CITY OF WESTMINSTER			
PLANNING APPLICATIONS SUB COMMITTEE	Date 26 October 2021	Classification For General Release	
Report of Director of Place Shaping and Town Planning		Ward(s) involved Marylebone High Street	
Subject of Report	15 Wimpole Street, London, W1G 9SU		
Proposal	Reinstatement of stairs and stone floor landings on ground and first floor and installation of a lift in the stairwell.		
Agent	Map Projects Ltd		
On behalf of	Partners FC Inc		
Registered Number	21/02967/LBC	Date amended/ completed	6 May 2021
Date Application Received	6 May 2021		
Historic Building Grade	Grade II listed building		
Conservation Area	Harley Street

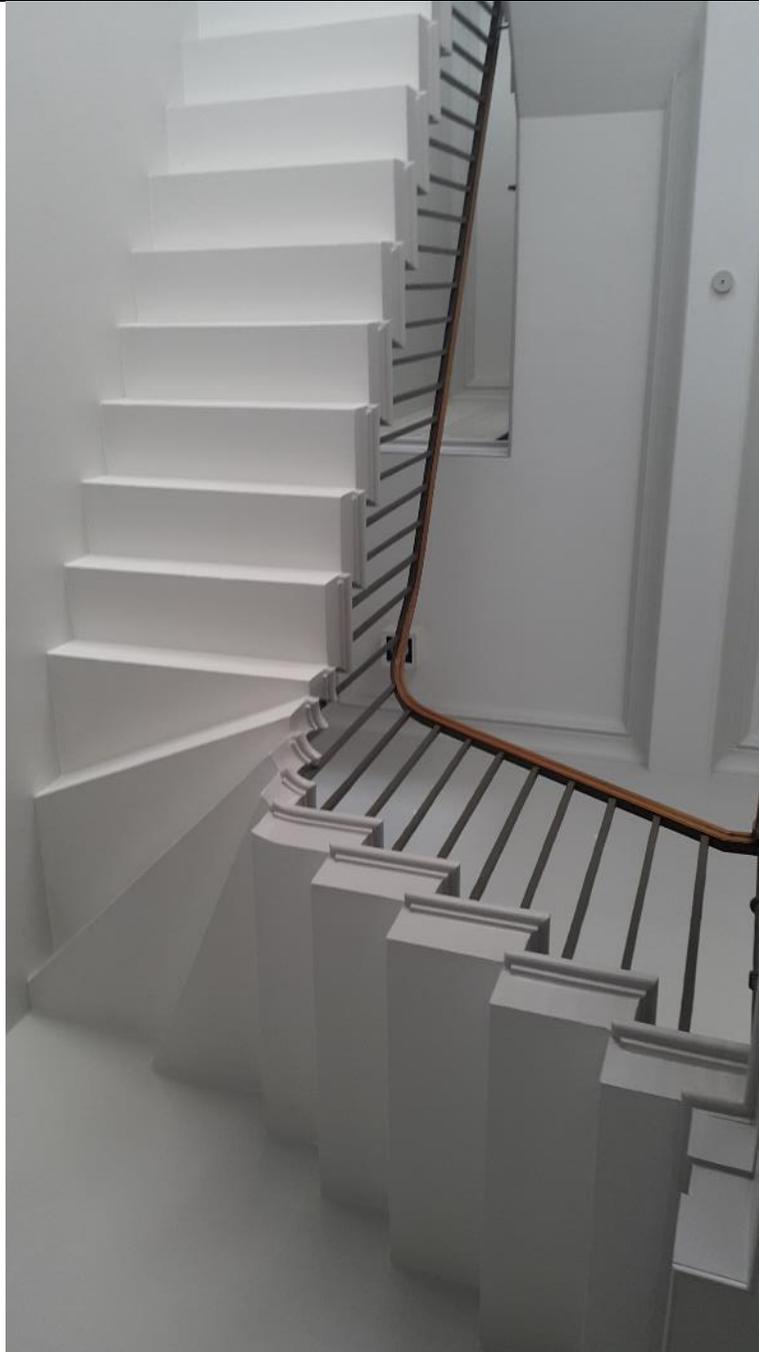
Photograph 1 – view from first floor landing of the ground floor base of the staircase, showing also the existing (modern) stub stair flight down to the lower ground floor that would be removed.

Photograph 2: View from ground floor up the stairwell, through which the lift shaft would rise. This shows the distinctive underside of the cantilevered stone staircase, and the modern built-out section of landing at second floor, which is proposed to be removed and opened back to the beam downstand line visible to the right, to reinstate the full height of the stairwell.

Photograph 3 – First floor landing, with flight down to ground floor to left, and flight up to the second floor to the right and top.

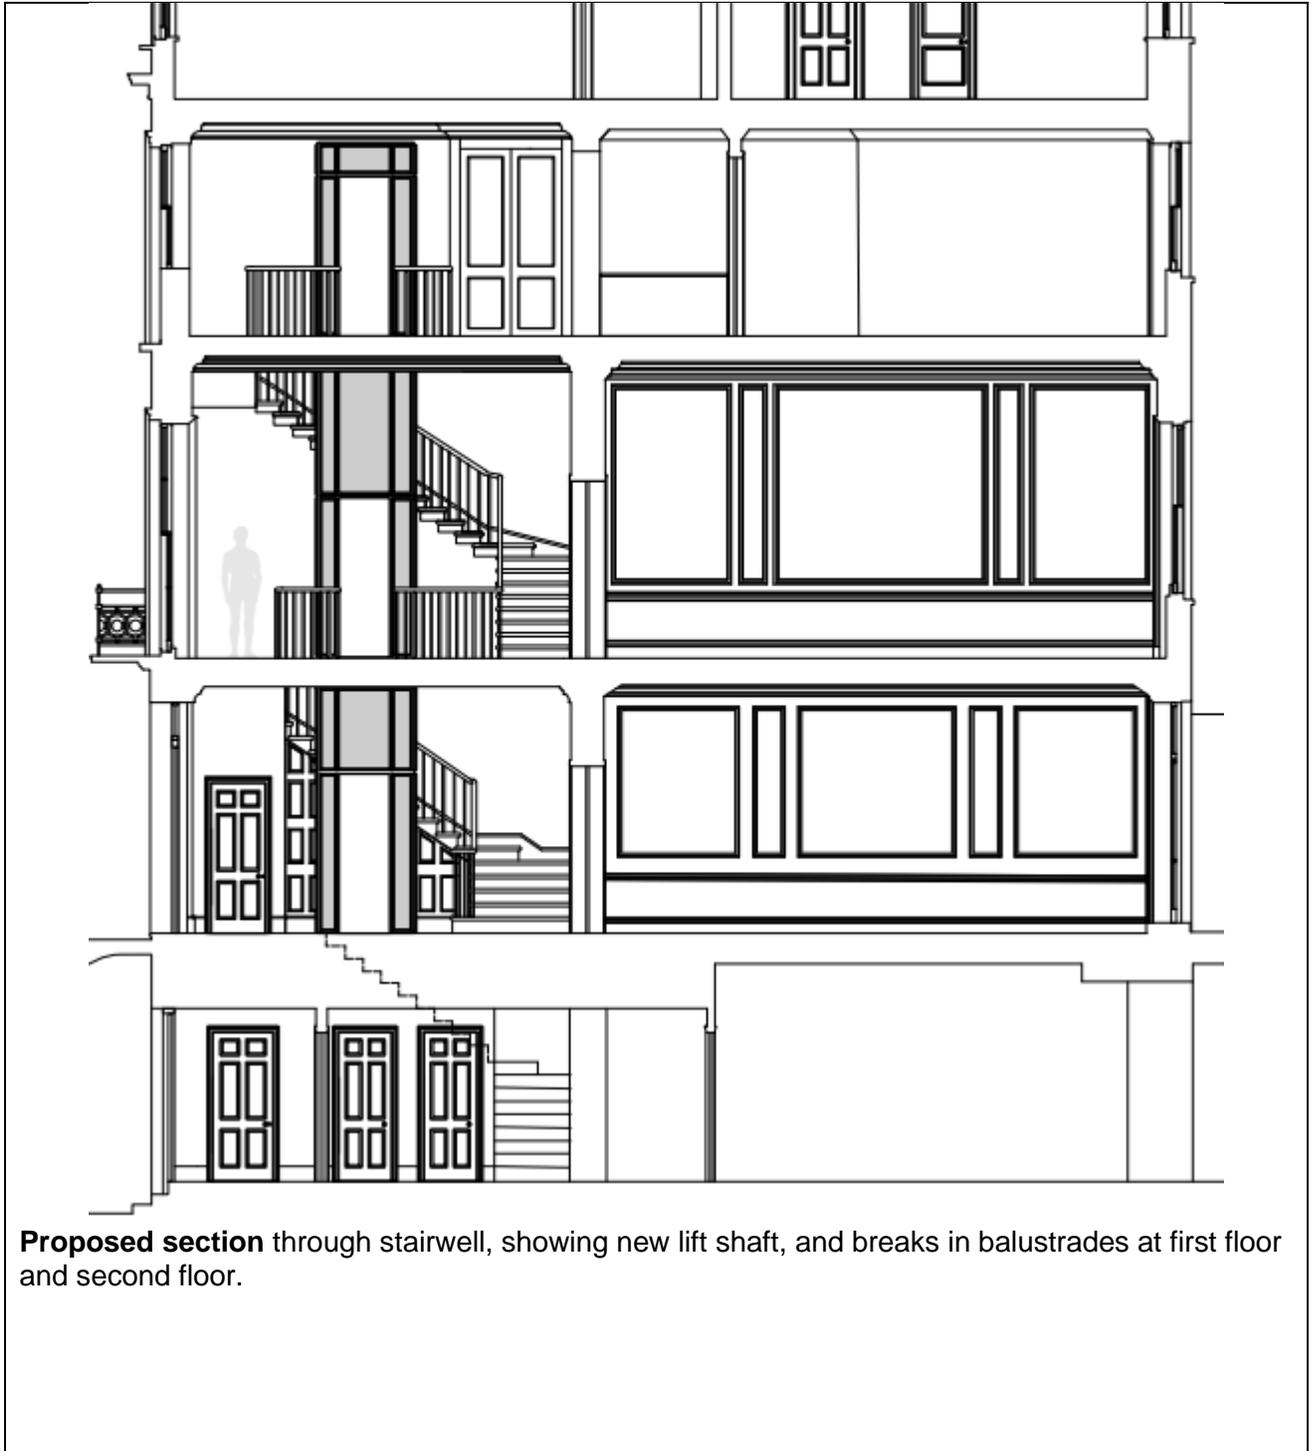
Above: Existing ground floor plan, showing in red modern stair treads to be removed.

Below: Proposed ground floor plan showing lift and reinstated historic layout of stairs to lower ground floor

Existing section through building, showing open stairwell, and existing modern arrangements at ground to lower ground, and at second floor.
